ADDENDUM # 2

DATE: JANUARY 5, 2022

STRICKLAND HALL – RENOVATE SPACE FOR COUNSELING
CENTER

PROJECT NUMBER: CP219031

POWER PLANS

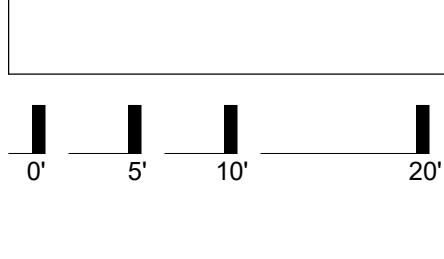
1. Drawing A700, W15 – DOOR SCHEDULE
ADD: Comment “3” to Door 412A
2. Drawing EP100
DELETE: Entire Drawing
REPLACE WITH: Attached Drawing EP100
CLARIFICATION: Add card reader to Door 412A.
3. Drawing EY100
DELETE: Entire Drawing
REPLACE WITH: Attached Drawing EY100
CLARIFICATION: Add card reader to Door 412A.
4. Drawing E500
DELETE: Entire Drawing
REPLACE WITH: Attached Drawing E500
5. Drawing E600
DELETE: Entire Drawing
REPLACE WITH: Attached Drawing E60
